Attachment III

Proposed Technical Specifications

R. E. Ginna Nuclear Power Plant
Spent Fuel Pool Re-racking Licensing Report
February 1997

Figure 3.7.13-1
Fuel Assembly Burnup Limits in Region 1

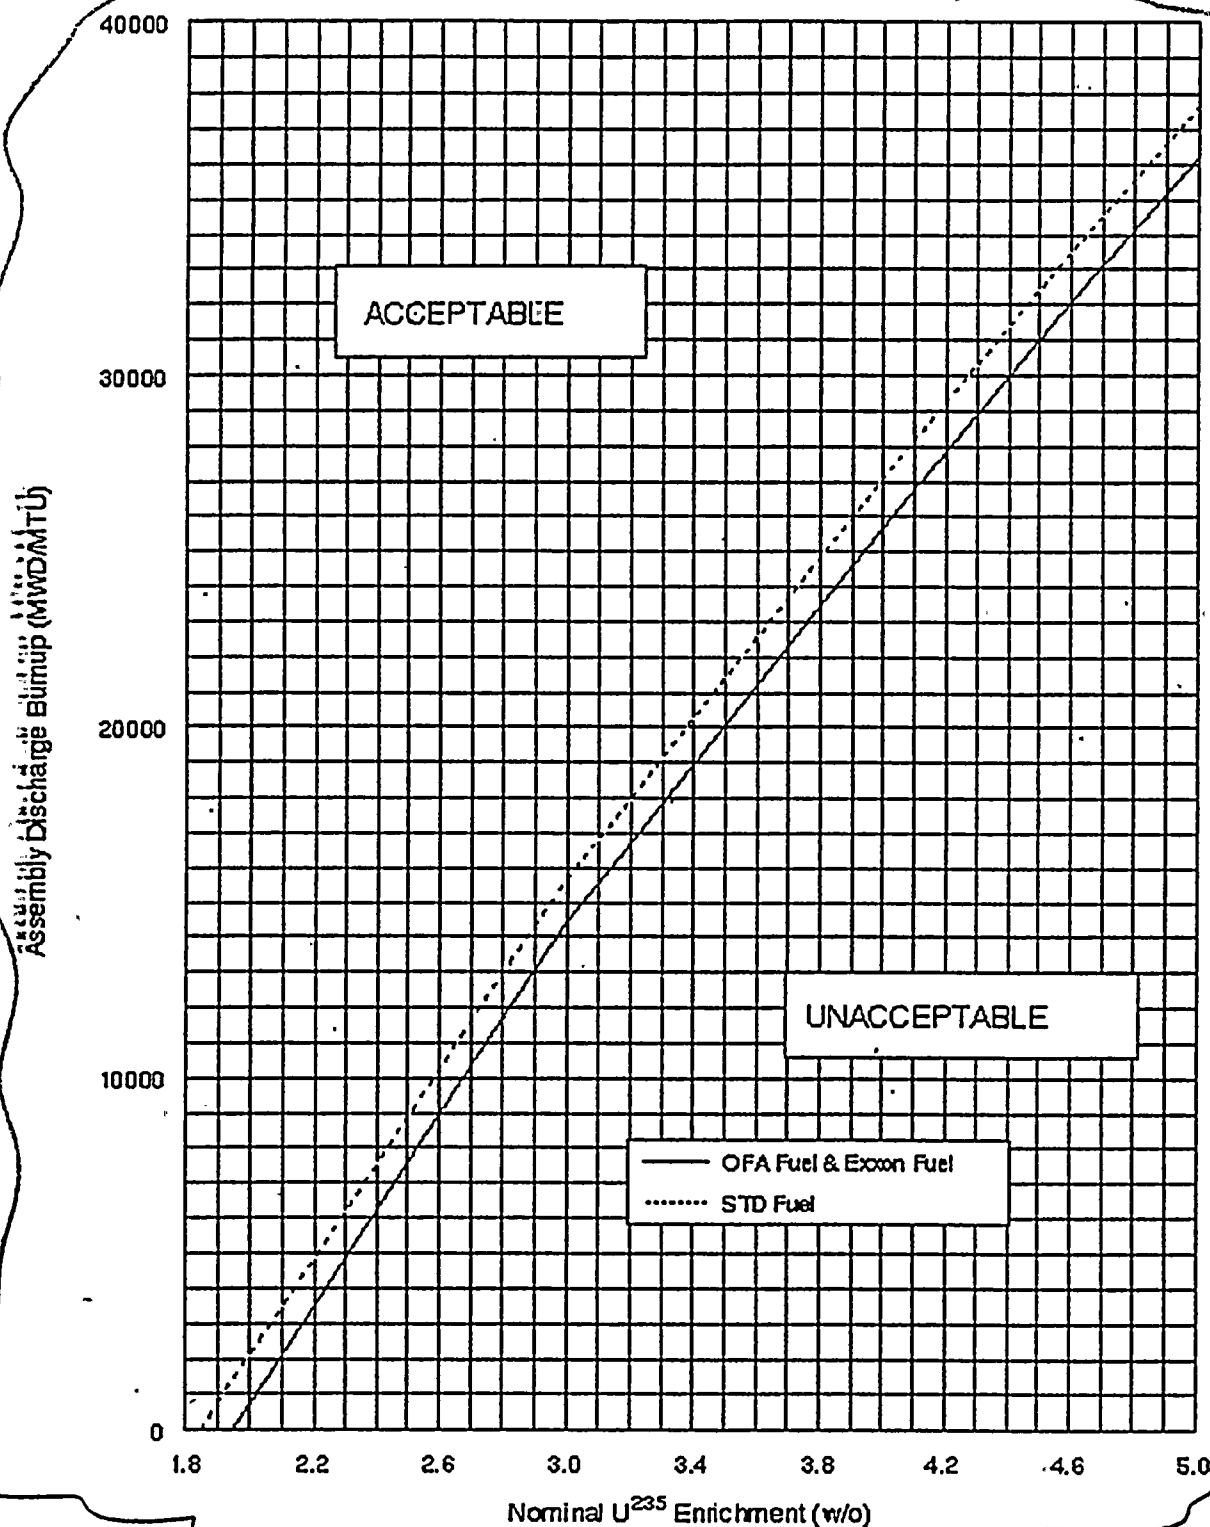
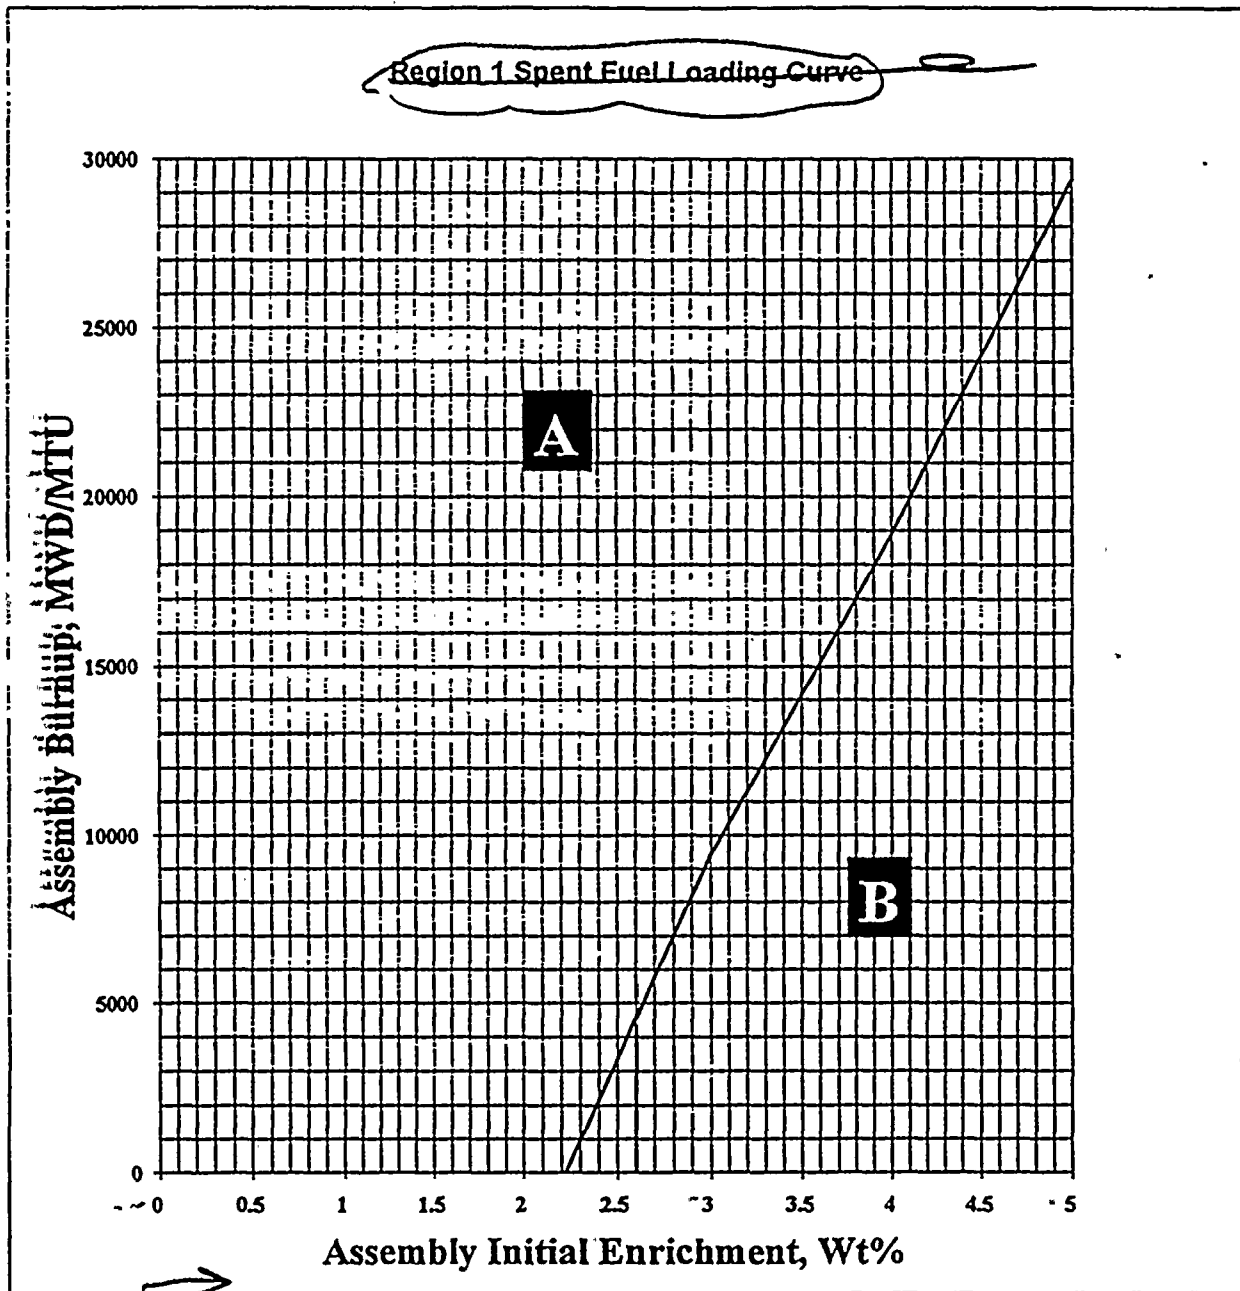
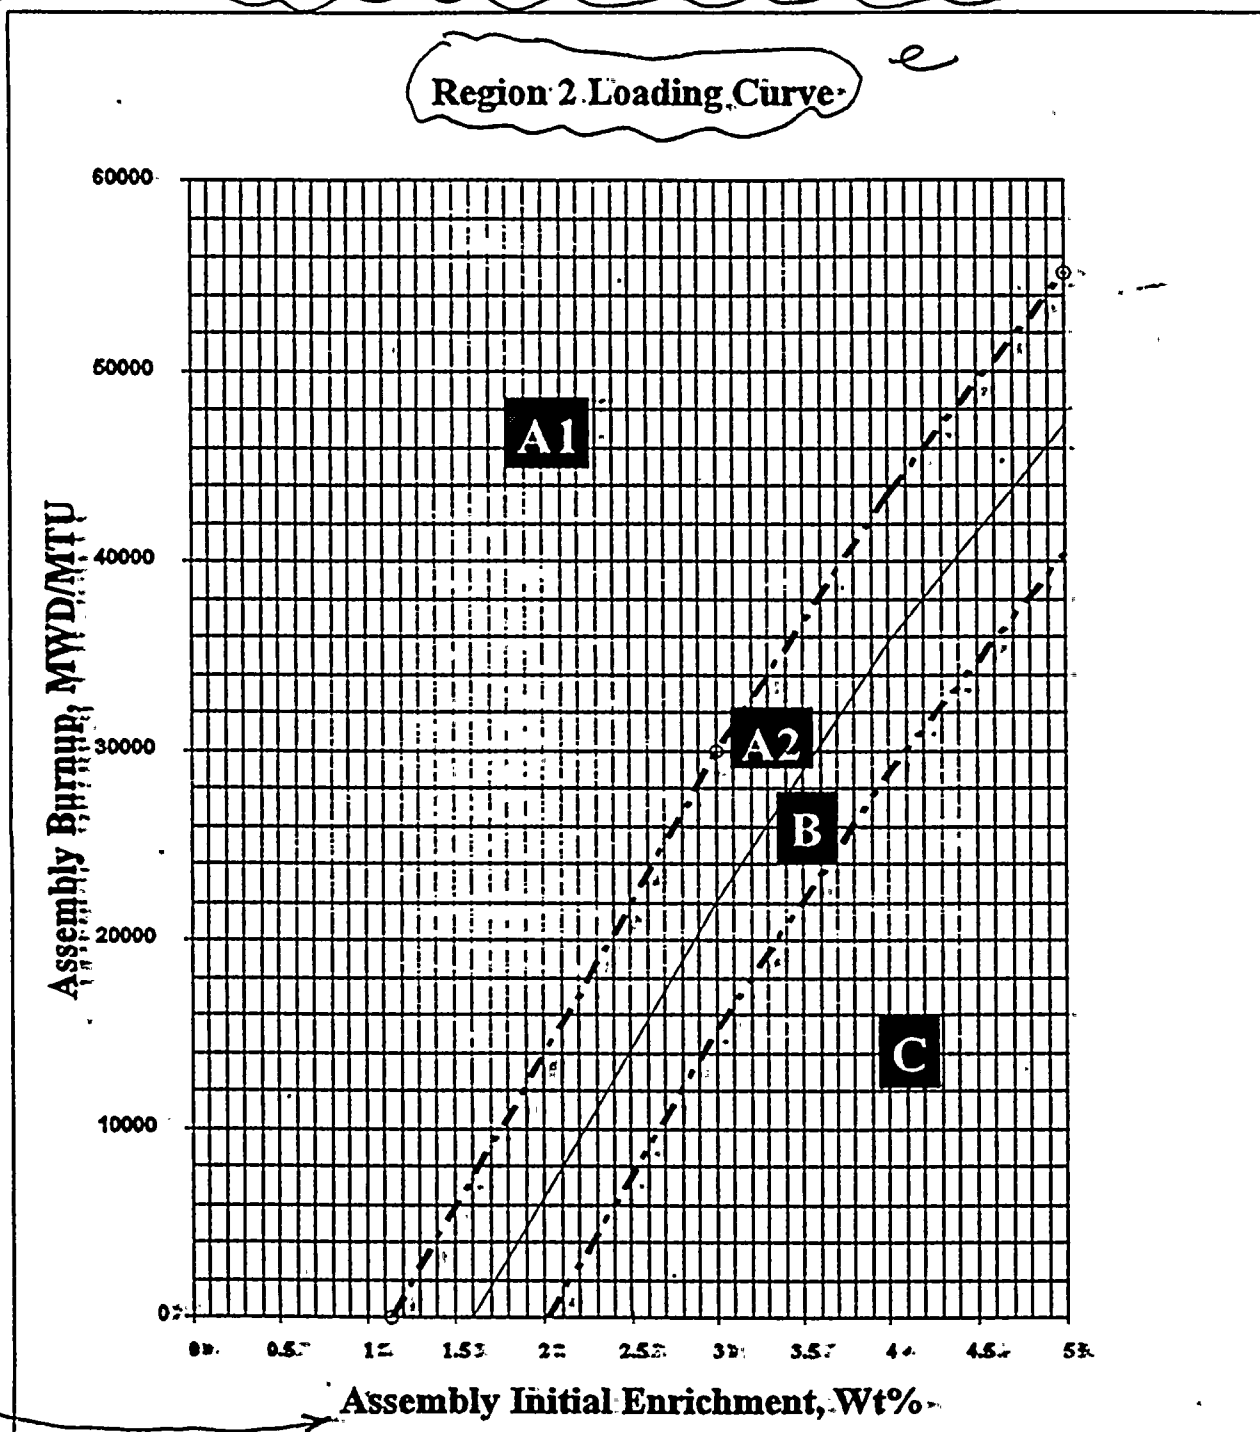
and shall have initial enrichment and burnup within the acceptable area of Figure 3.7.13-1

- a. Fuel assemblies in Region 1 shall have a K-infinity of ≤ 1.458 ; and
- b. Fuel assemblies in Region 2 shall have initial enrichment and burnup within the acceptable area of the Figure 3.7.13-1.

Insert new Figure
3.7.13-1 and 3.7.13-2

- a. Fuel assemblies in Region 1 shall have a K-infinity of ≤ 1.458 and shall have initial enrichment and burnup within the acceptable area of Figure 3.7.13-1; and
- b. Fuel assemblies in Region 2 shall have initial enrichment and burnup within the acceptable area of the Figure 3.7.13-2.

Figure B 3.7.13-1
Spent Fuel Pool

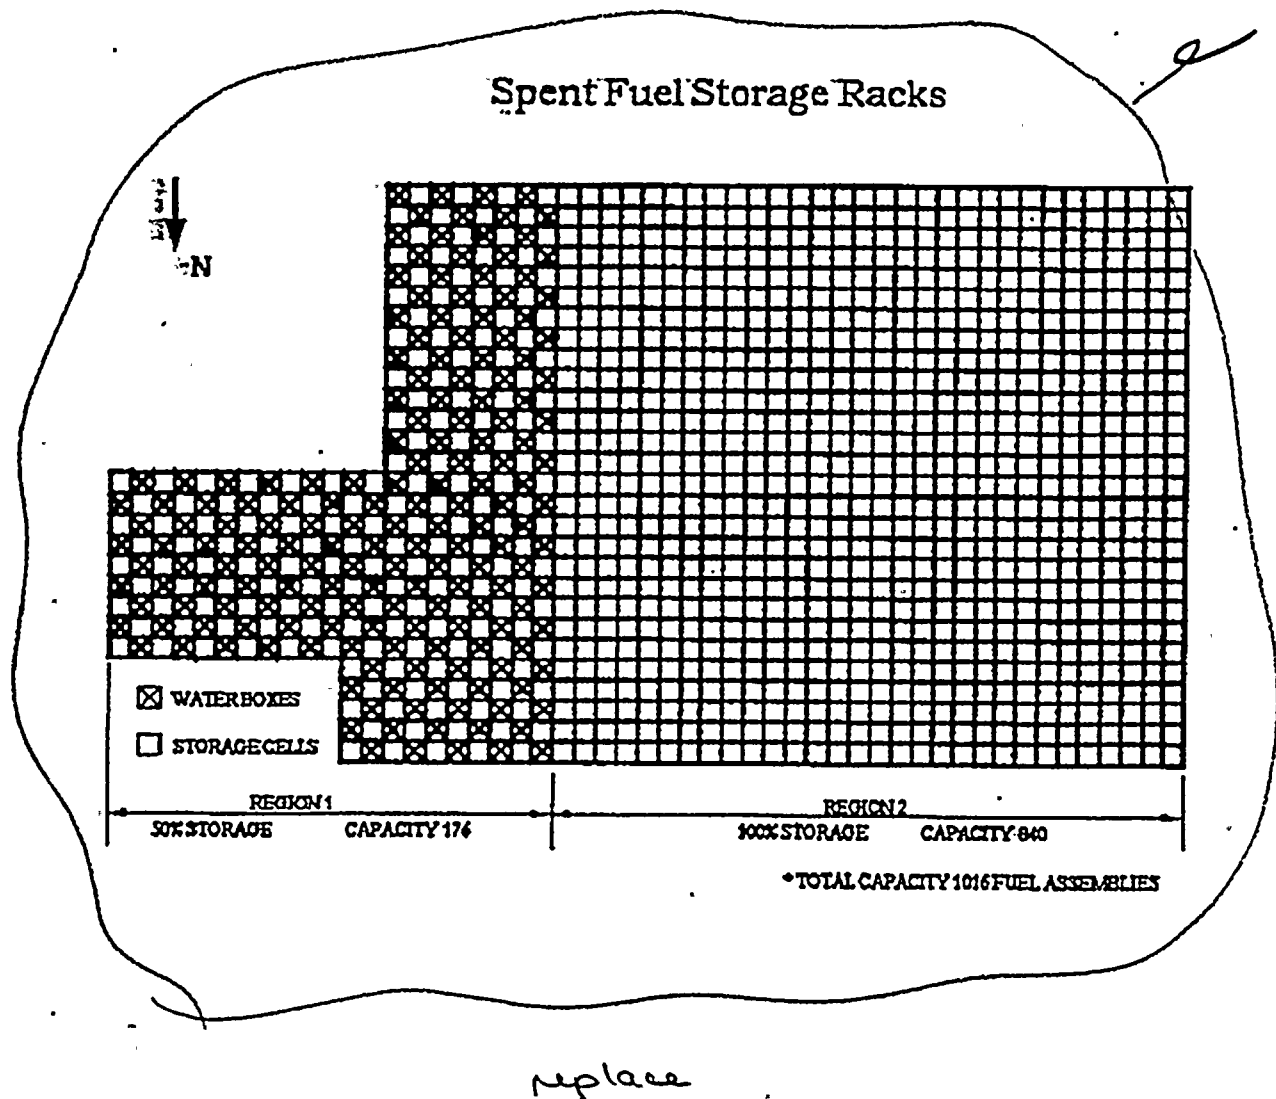
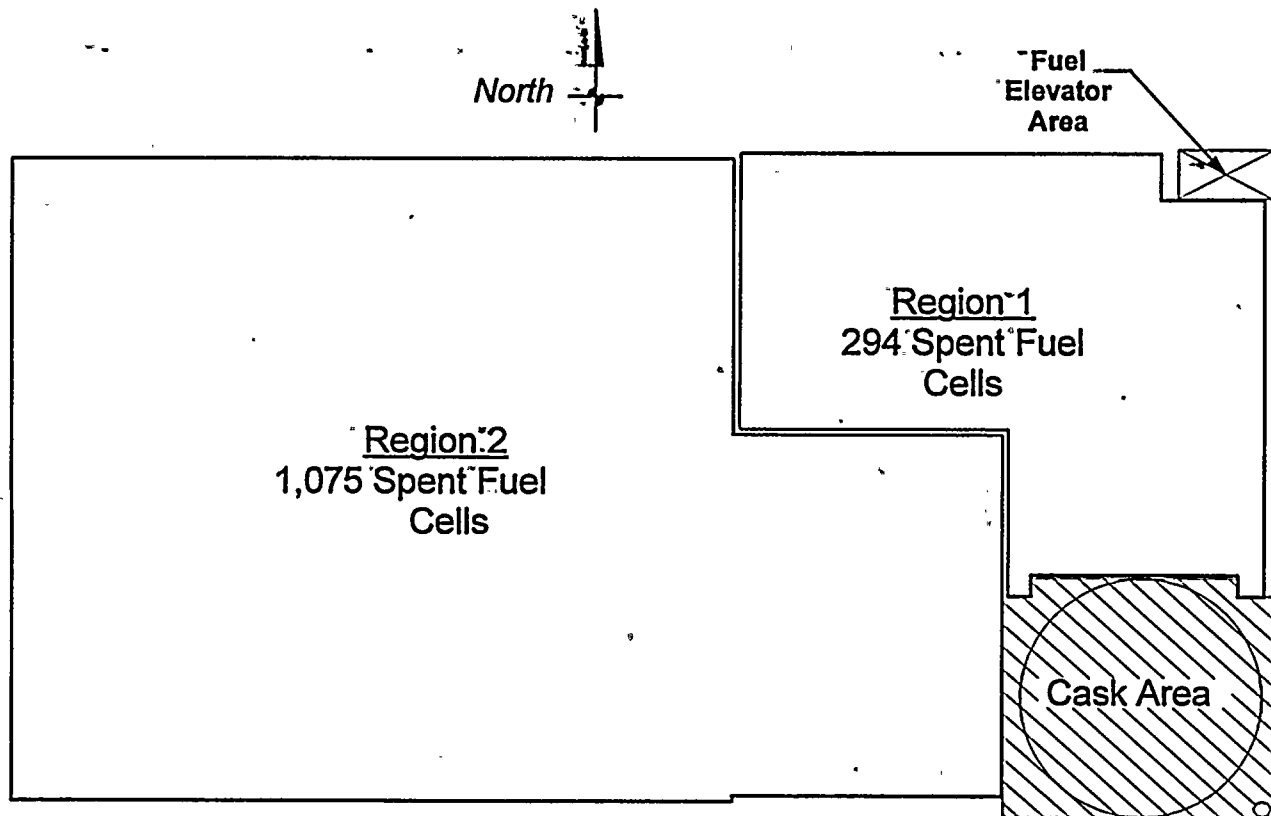
The spent fuel pool (SFP) is divided into two separate and distinct regions (see Figure B 3.7.13-1) which, for the purpose of criticality considerations, are considered as separate pools (Ref. 1). Region 1, with ~~176~~ storage positions, is designed to accommodate new or spent fuel utilizing a ~~two of four~~ checkerboard arrangement. A fuel assembly with an enrichment of ≤ 4.05 wt% can be stored at any available location in Region 1 since the accident analyses were performed assuming that Region 1 was filled with fuel assemblies of this enrichment. A fuel assembly with an enrichment > 4.05 wt% U-235 can also be stored in Region 1 provided that integral burnable poisons are present in the assemblies such that k-infinity is ≤ 1.458 . The existing design uses Integral Fuel Burnable Absorbers (IFBAs) as the poison for fuel assemblies with enrichments > 4.05 wt%. IFBAs consist of neutron absorbing material which provides equivalencing reactivity holddown (i.e., neutron poison) that allows storage of higher enrichment fuel. The neutron absorbing material is a non-removable or integral part of the fuel assembly once it is applied. The infinite multiplication factor, K-infinity, is a reference criticality point of each fuel assembly that if maintained ≤ 1.458 , will result in a $k_{eff} \leq 0.95$ for Region 1. The K-infinity limit is derived for constant conditions of normal reactor core configuration (i.e., typical geometry of fuel assemblies in vertical position arranged in an infinite array) at cold conditions (i.e., 68°F and 14.7 psia).

Region 2, with ~~840~~ storage positions, is designed to accommodate fuel of various initial enrichments which have accumulated minimum burnups within the acceptable domain according to Figure 3.7.13-1, in the accompanying LCO. The storage of fuel assemblies, which are within the acceptable range of Figure 3.7.13-1 in Region 2 ensures a $k_{eff} \leq 0.95$ in this region.

Figure 3.7.13-1
Fuel Assembly Burnup Limits in Region 1

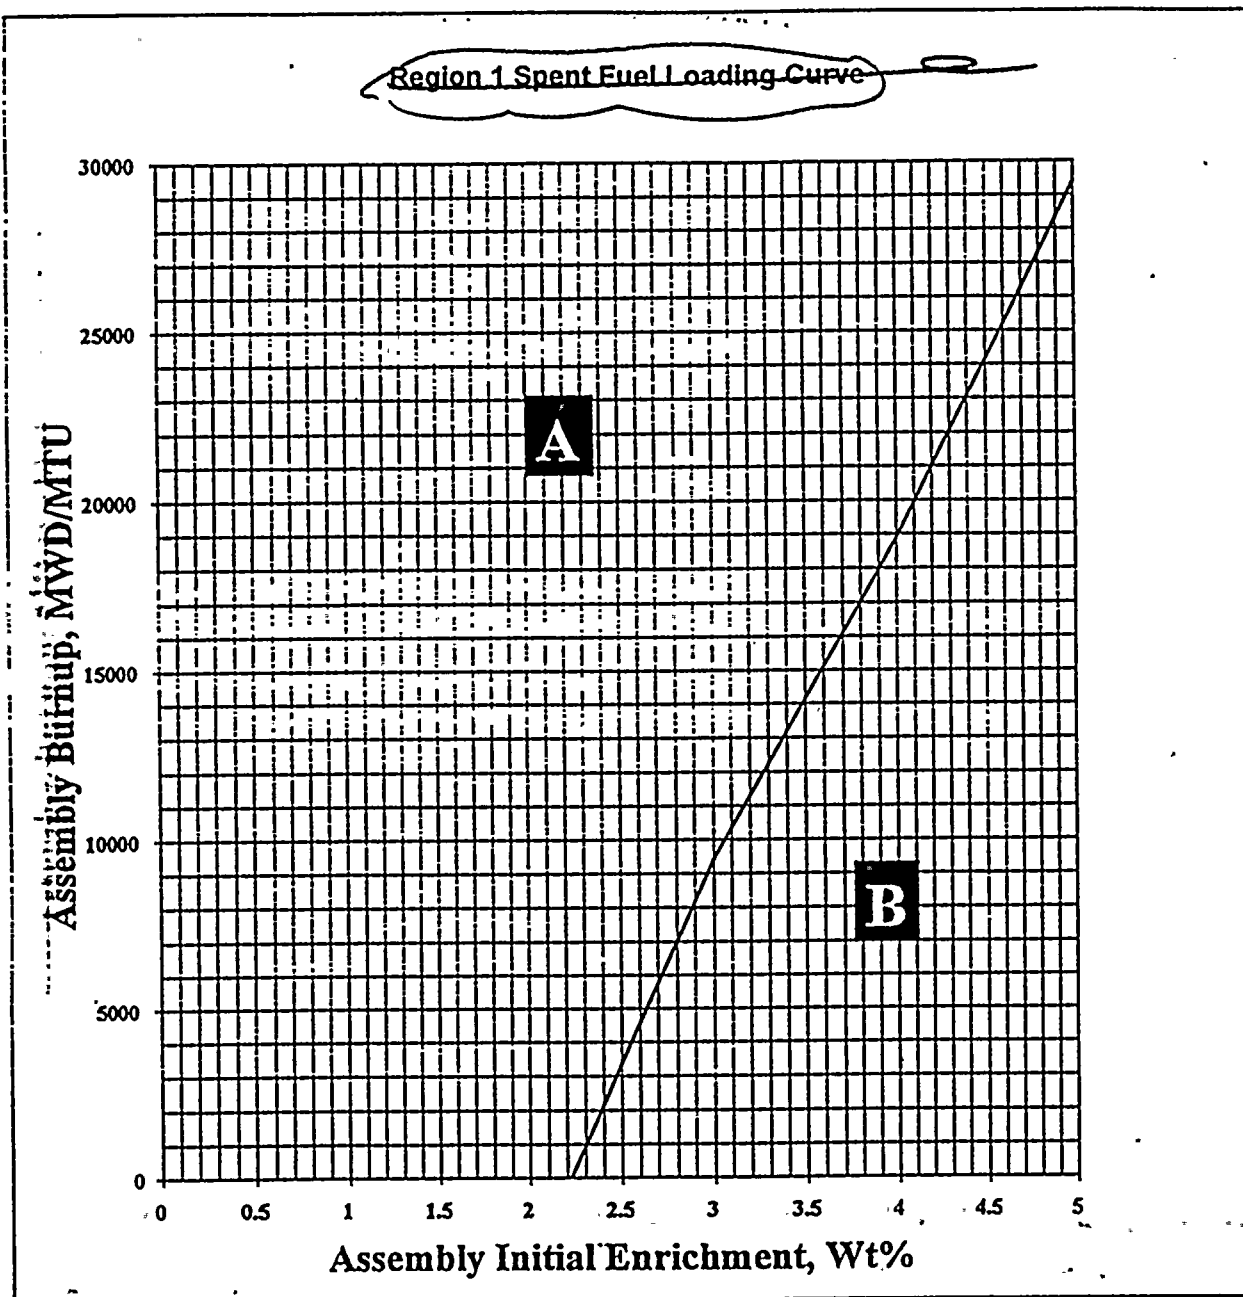
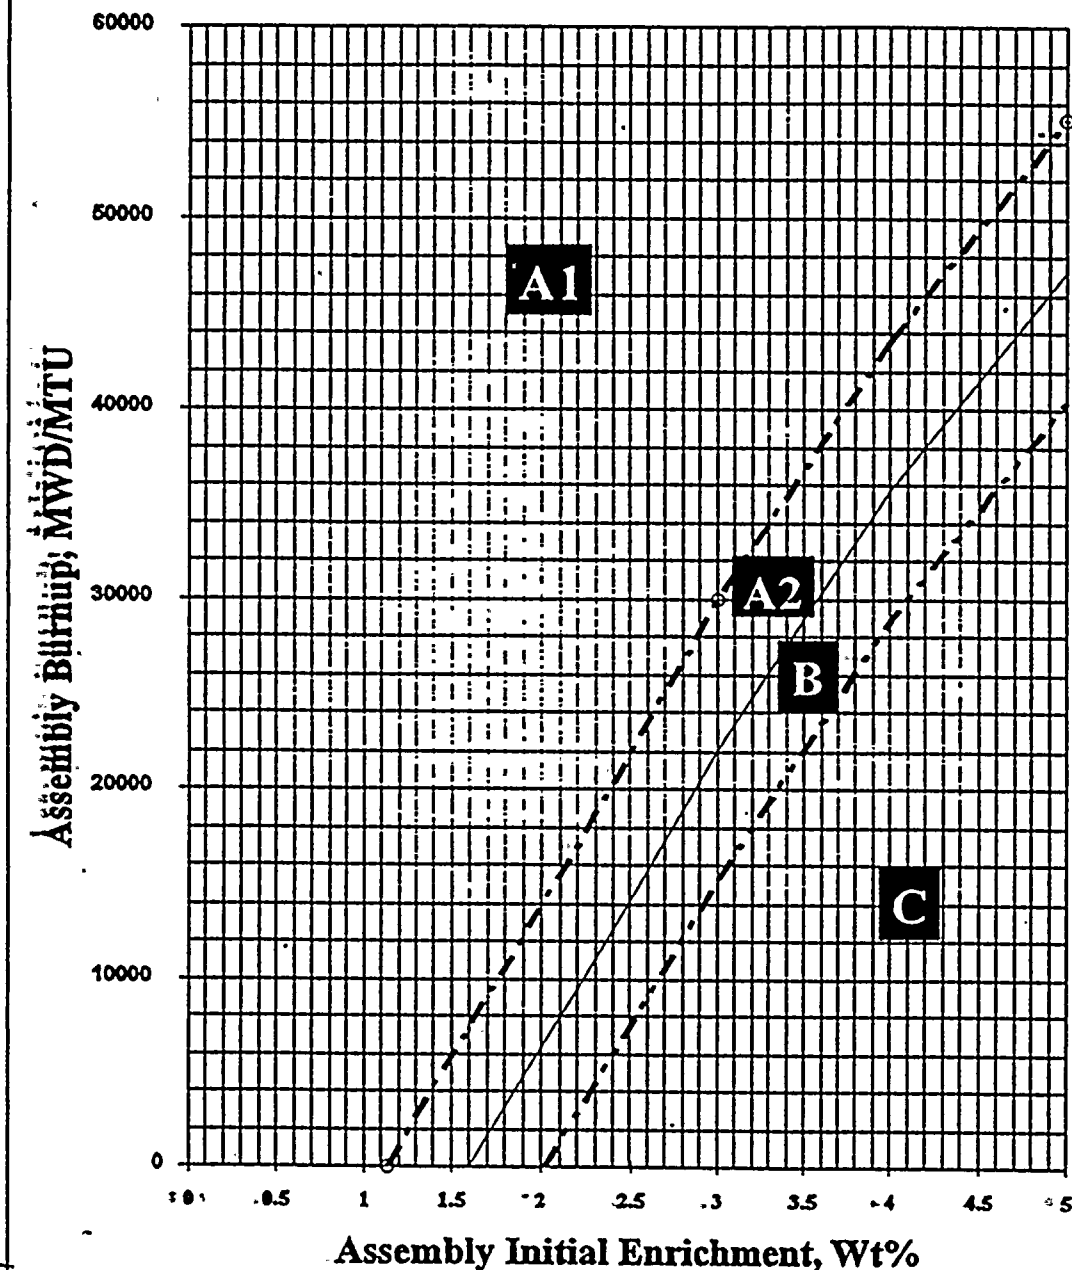
SURVEILLANCE	FREQUENCY
SR 3.7.13.1 Verify by administrative means the K-infinity of the fuel assembly is ≤ 1.458 and that the initial enrichment and burnup is in accordance with Figure 3.7.13-1.	Prior to storing the fuel assembly in Region 1
SR 3.7.13.2 Verify by administrative means the initial enrichment and burnup of the fuel assembly is in accordance with Figure 3.7.13-2.	Prior to storing the fuel assembly in Region 2
